PL202400061

PIG ATE MY PIZZA

LAND USE APPLICATION 05/01/2024

TRAVAIL - PIG ATE MY PIZZA 2.0

DEMOLITION PLAN

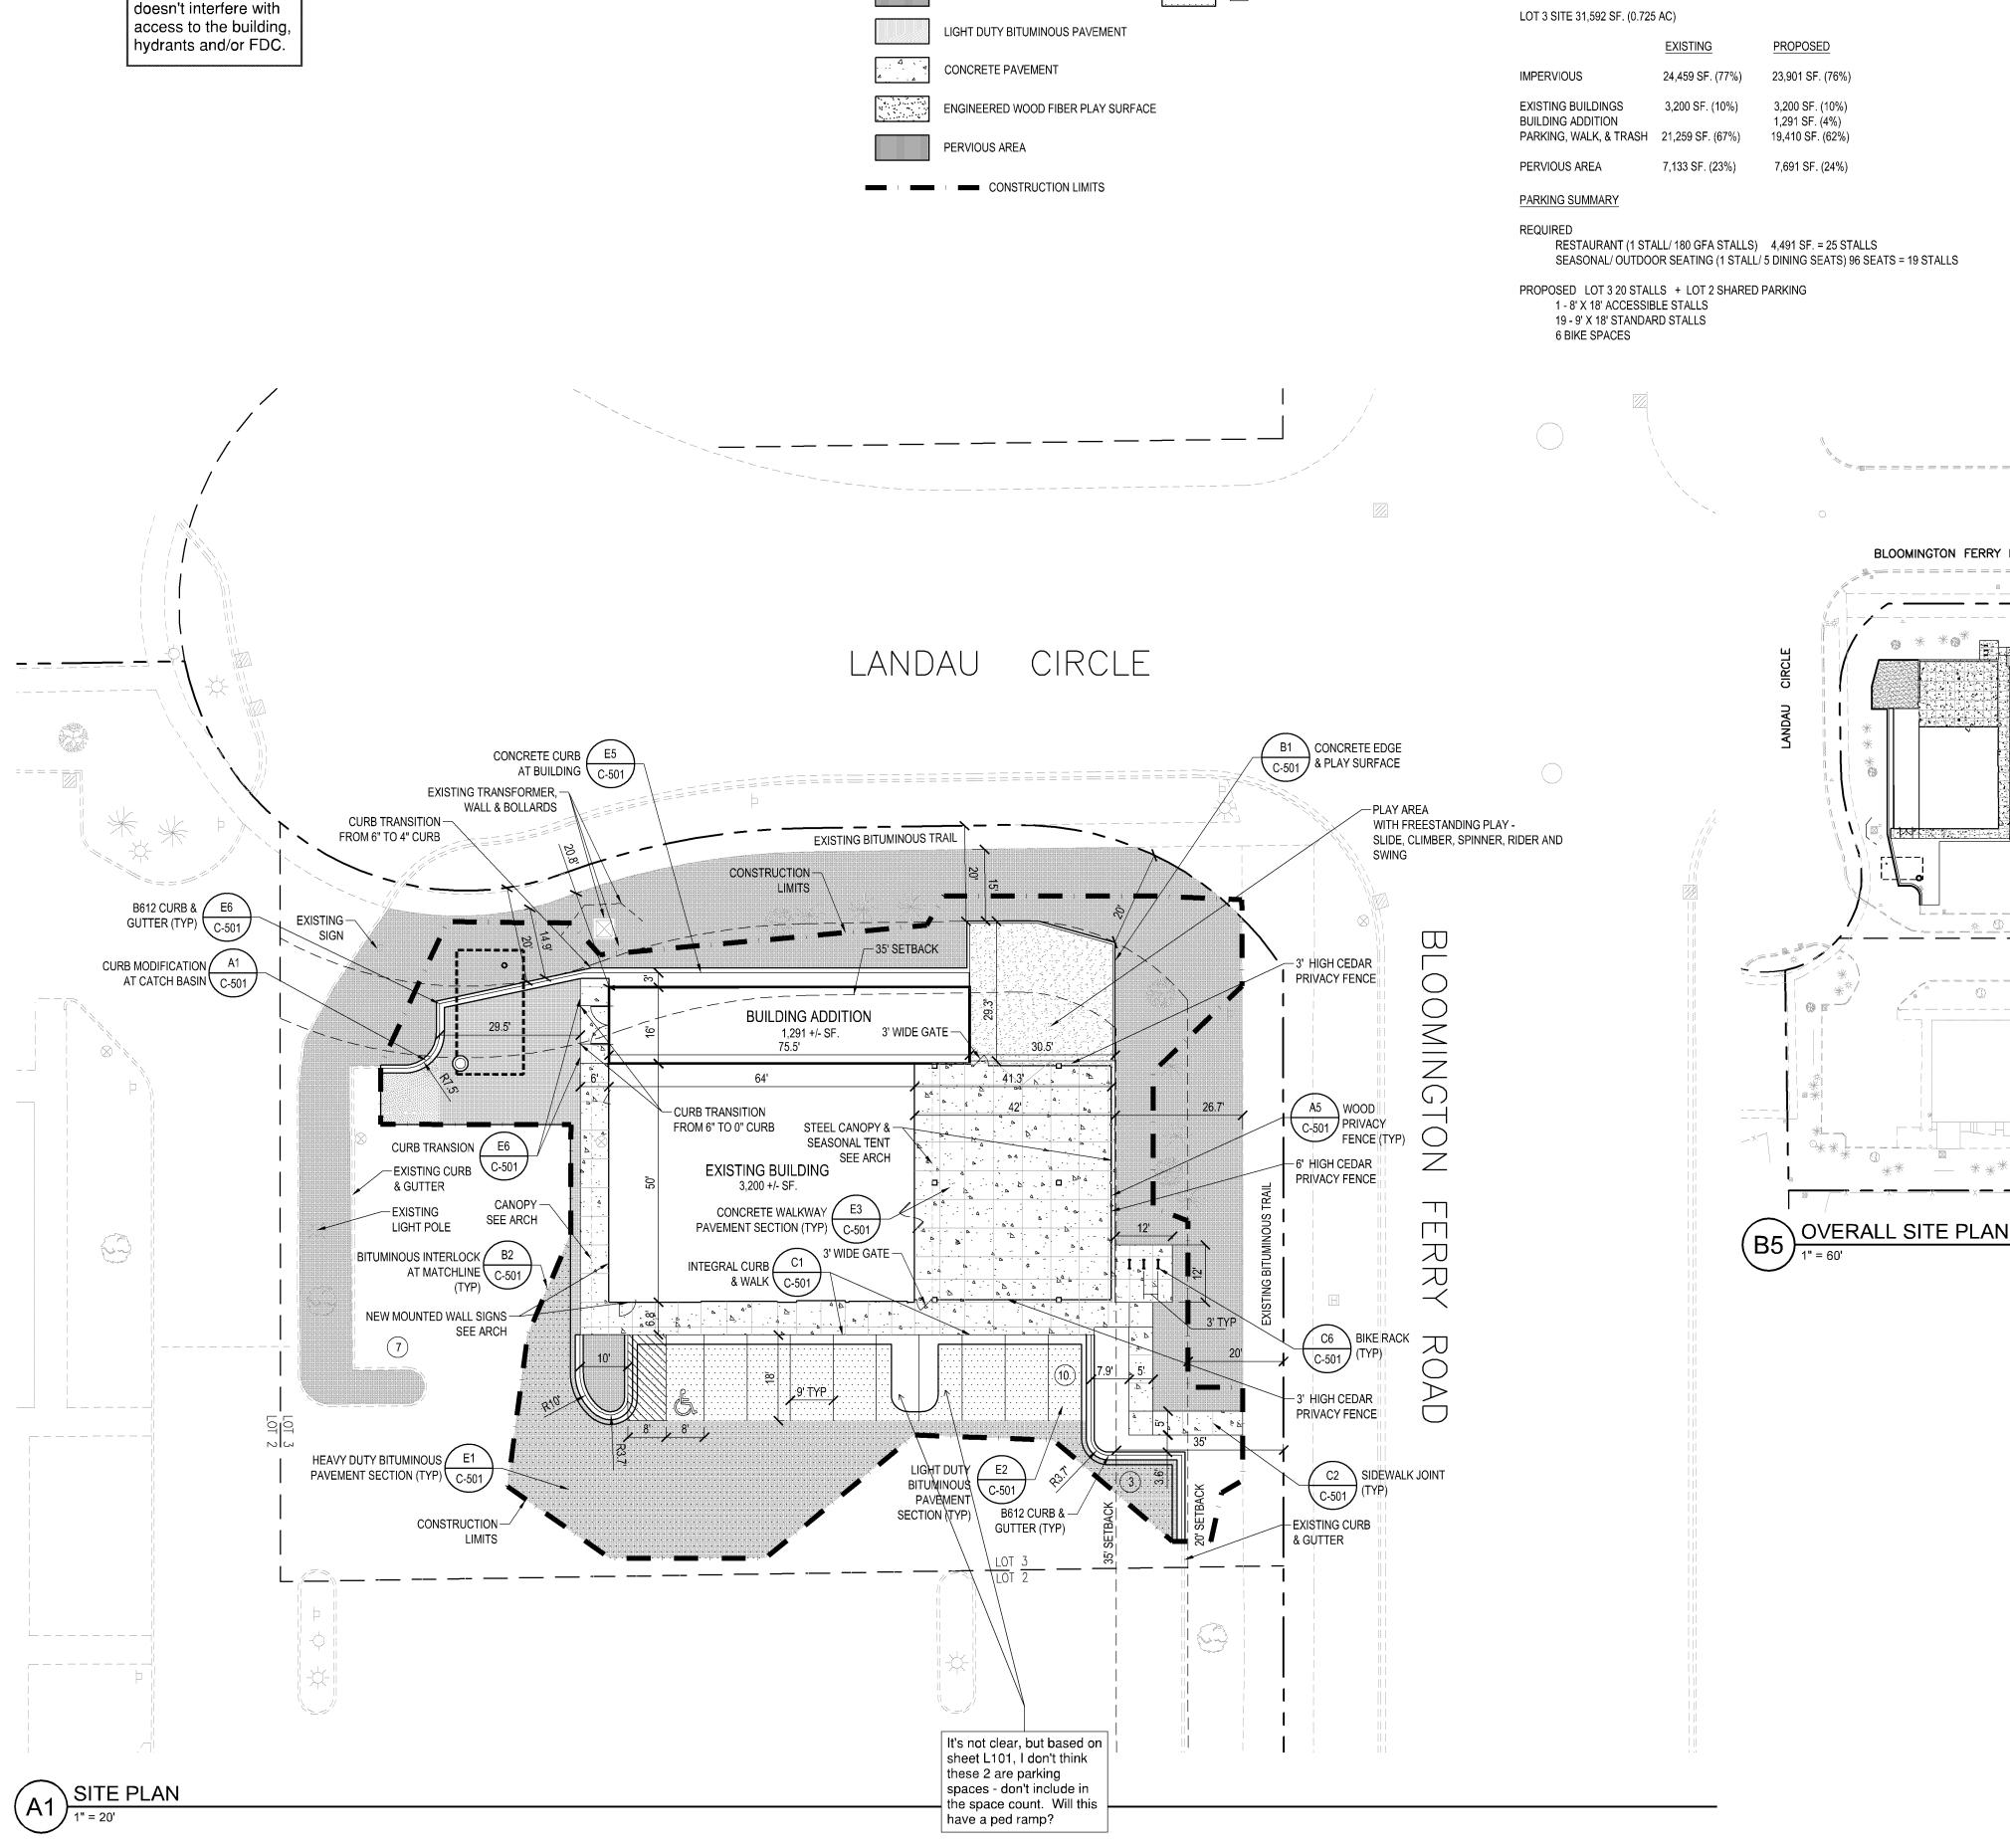
Show easements on all sheets. 10' drainage and utility easement along street frontage. 15' sidewalk/bikeway easement along Bloomington Ferry Road and 10' walkway easement along Landau Circle.

SITE PLAN

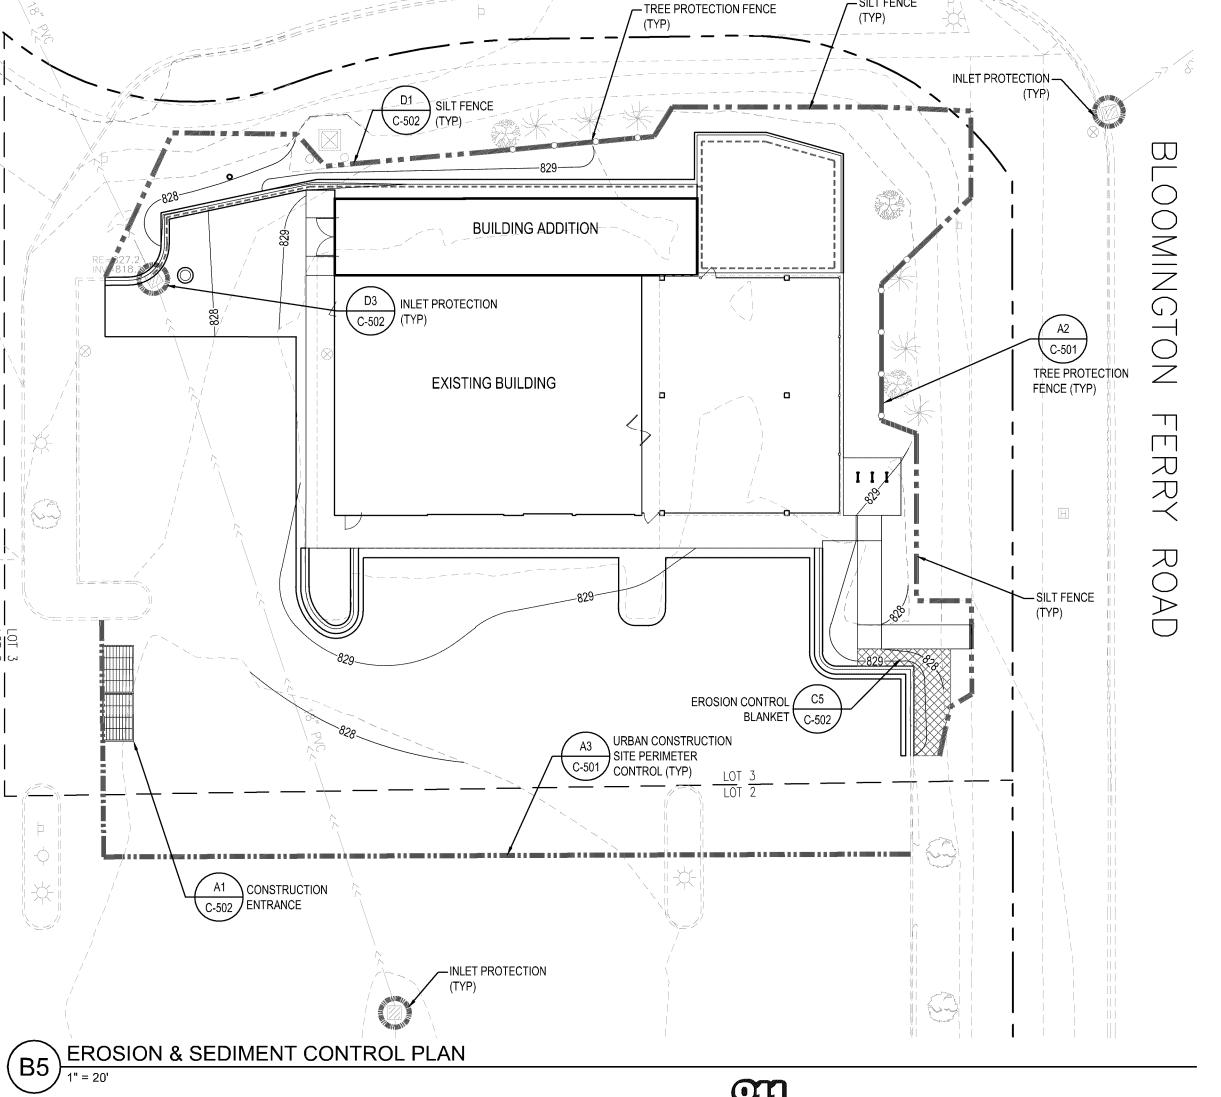
Ensure landscaping

TITLESHEET

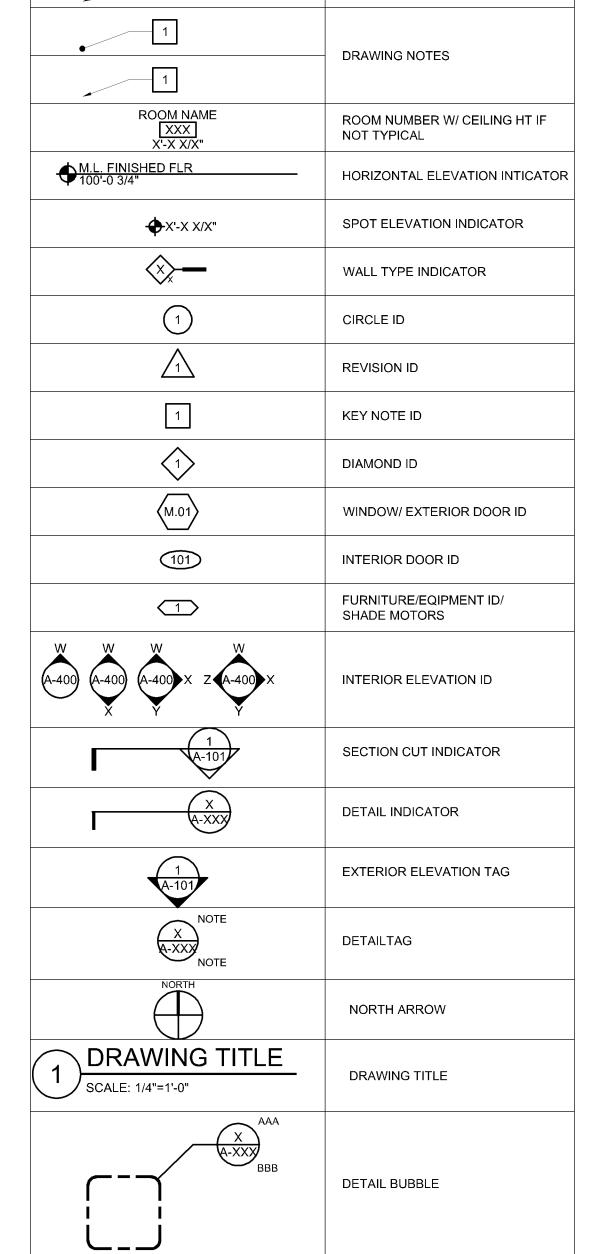
Review application with plan submittal for each proposed food facility.

Provide an Environmental Health Plan

Provide specification sheets during plan submittal on all new and used equipment being proposed for use in this facility.

Any additions or changes to food service must be approved by the Health Department prior to construction if required

Provide a minimum of ceramic tile to six feet in neight and two feet beyond all two- and threecompartment sinks, dish washing machines, and food preparation areas designated on the plan. Stainless steel may be used in place of ceramic tile. (City Code Sec. 14.452 (a)(4)(C))
